Mapleton City Council Staff Report

Consideration of a Resolution approving the Final Plat for the Pheasant View Plat "B" Subdivision consisting of three lots, and a Project Plan for a 69 bed assisted living center located at approximately 800 S and Highway 89 in the General Commercial (GC-1) zone.

MAPLETON CITY DEVELOPMENT REVIEW COMMITTEE MINUTES

Address the following concerns in revised drawings:
Project: Pheasant View "B" Assisted Living Date: January 29, 2014

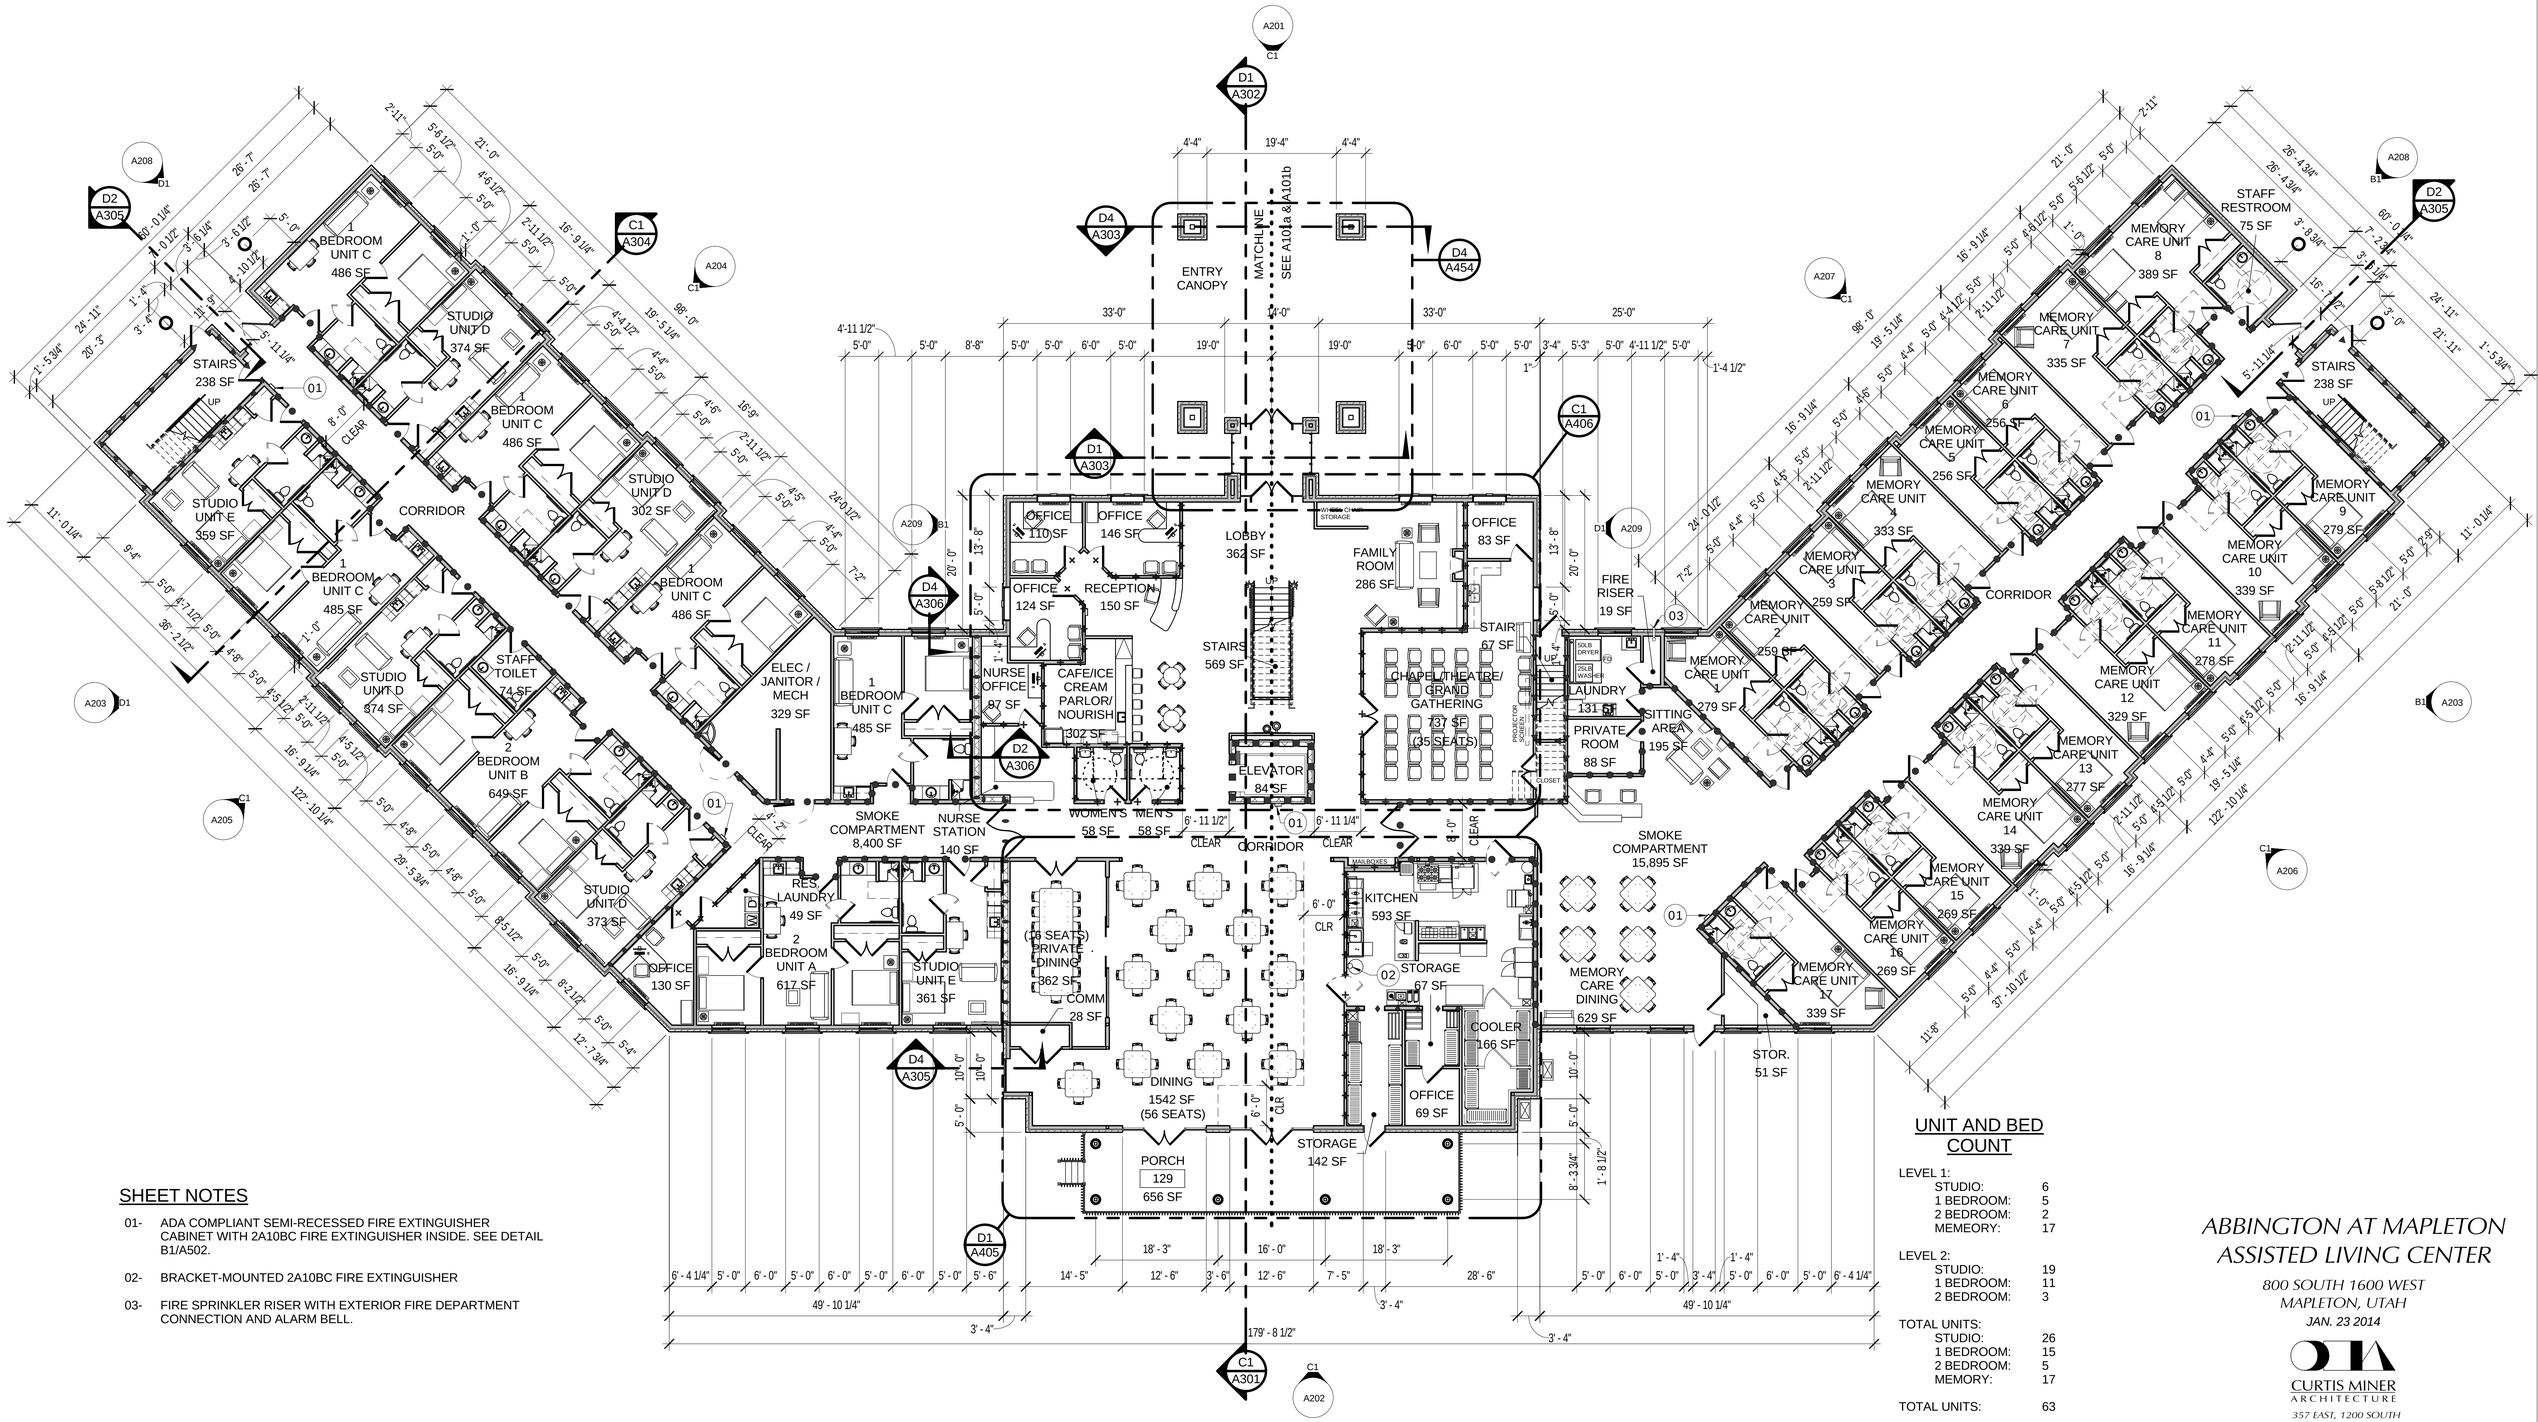
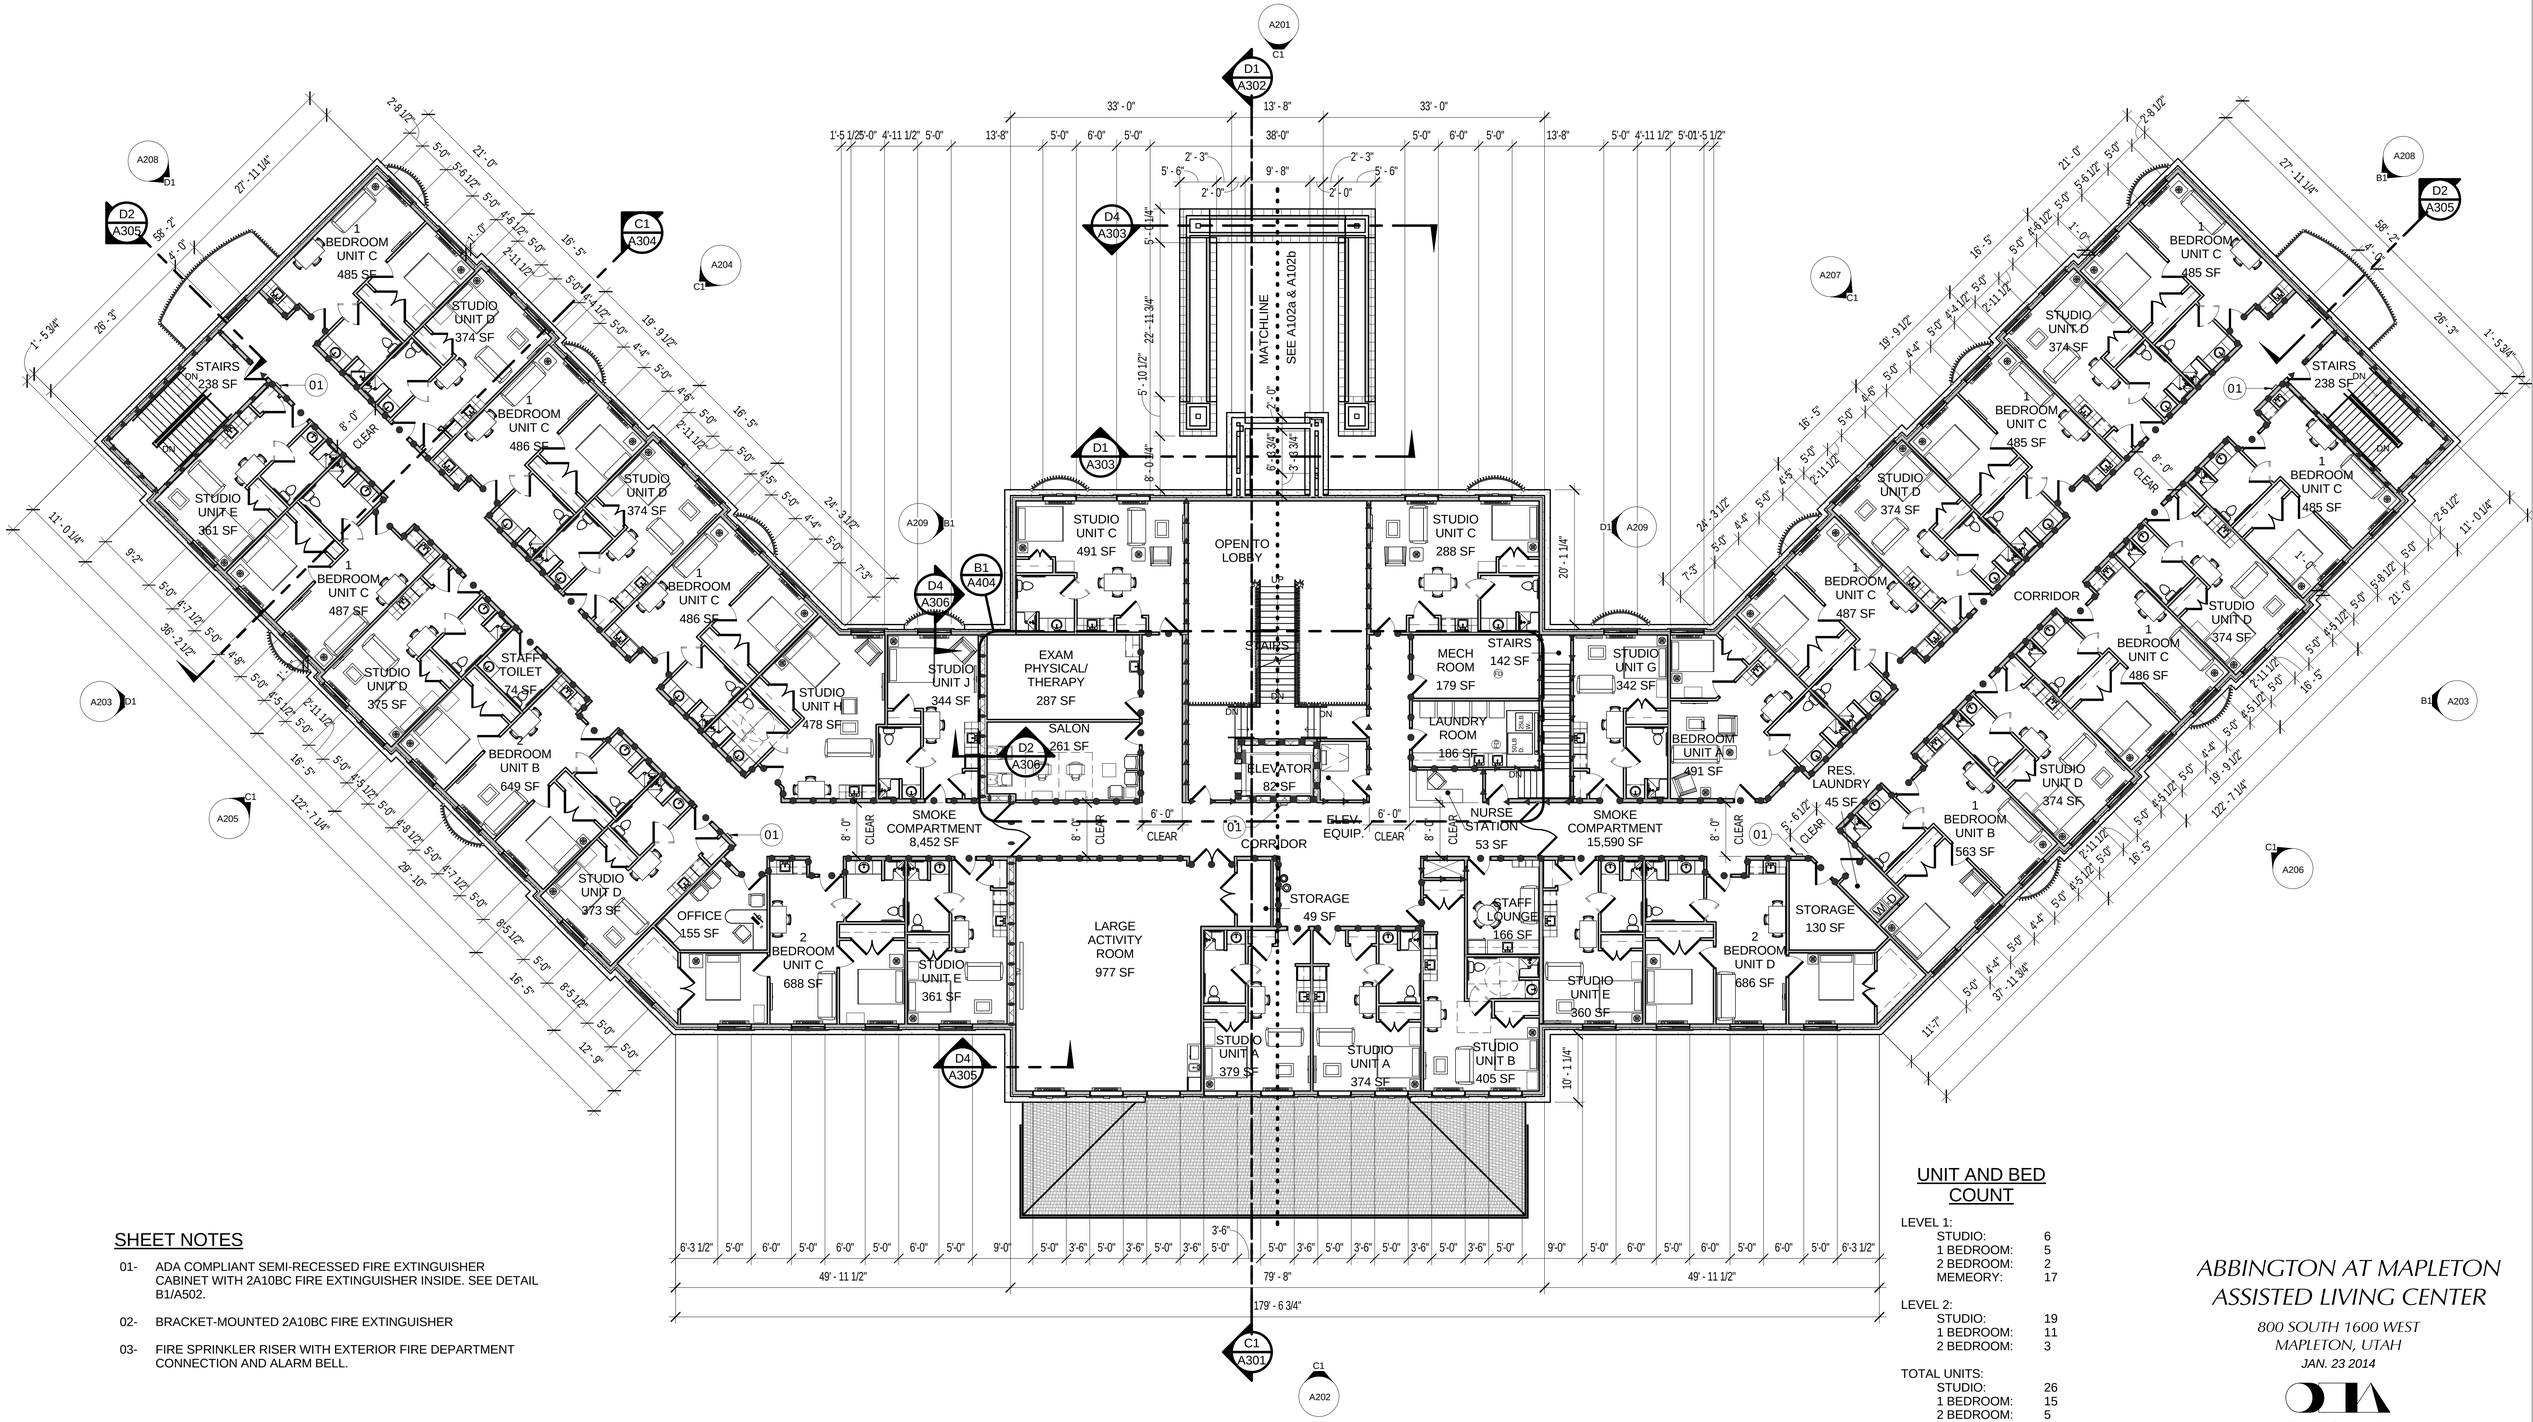
Response: The proposed assisted living center is a three-story (2-story finished) building with a roof pitch of 6:12. The exterior materials include a brick veneer along much of the lower level and a mix of horizontal hardy board and hardy board shingles on the upper level. The brick veneer wraps around the entire building, rather than on just the front façade, which improves the authenticity of the design.

Several dormers are proposed on the roof, which help add architectural detail. The proposed building is architecturally consistent and visually interesting. The proposed materials will provide a high quality appearance as envisioned in the General Plan.

ABBINGTON SENIOR COMMUNITY
1483 WEST 800 SOUTH
MAPLETON, UT 84664
PLANTING PLAN

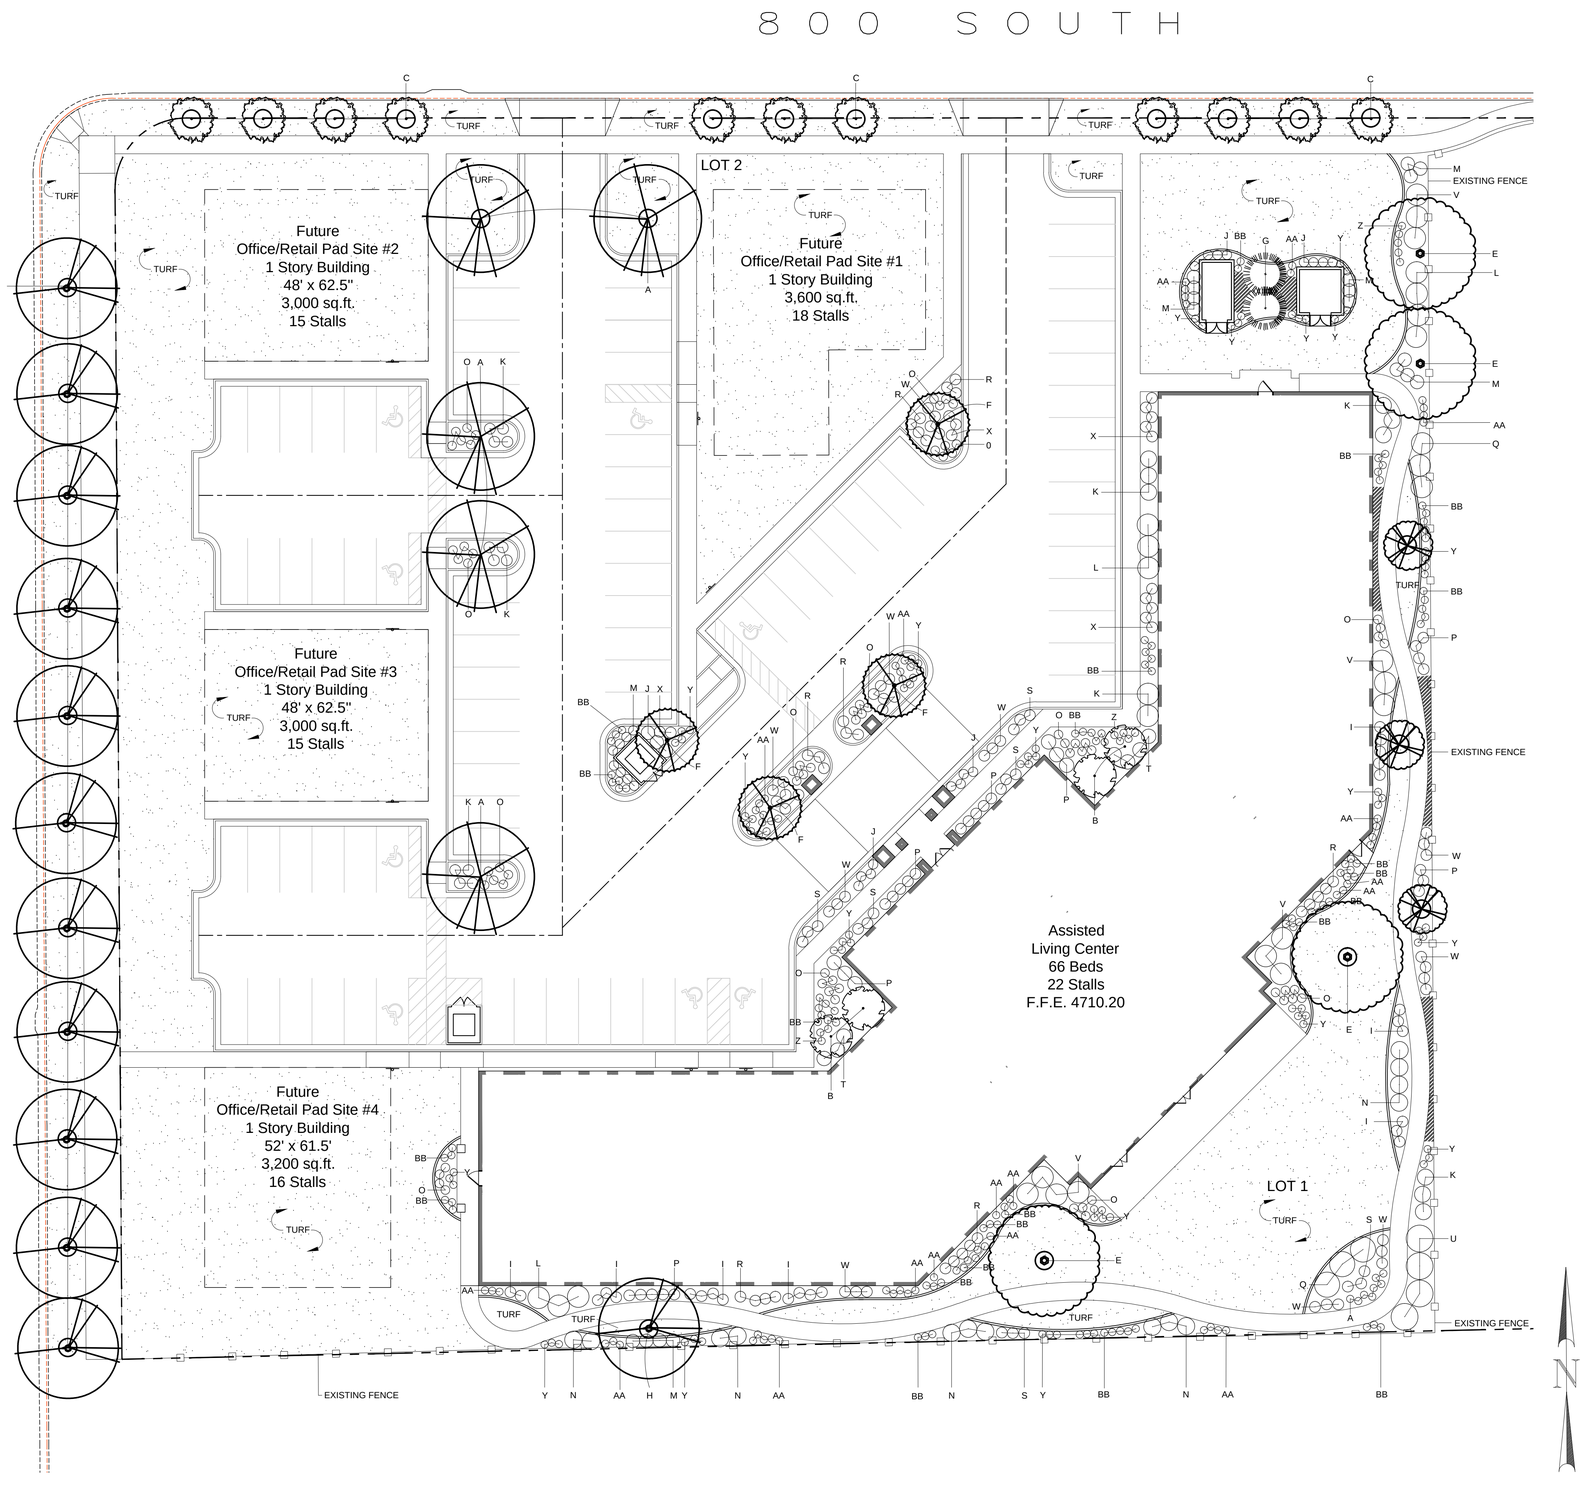
The proposed landscape plan includes the planting of trees and sod along each street frontage, sod around each building pad, trees and planters in the parking lot and other landscaping around the assisted living center. The proposed landscaping will create a quality appearance and is consistent with the landscape ordinance.

There is a note on the plans that indicates that the landscaping will be installed by each property owner. Staff is supportive of this approach with that with the exception of the planters along the public rights-of-way. Staff has added a special condition requiring the landscaping along Highway 89 and along 800 S to be installed as part of the construction of the assisted living center.
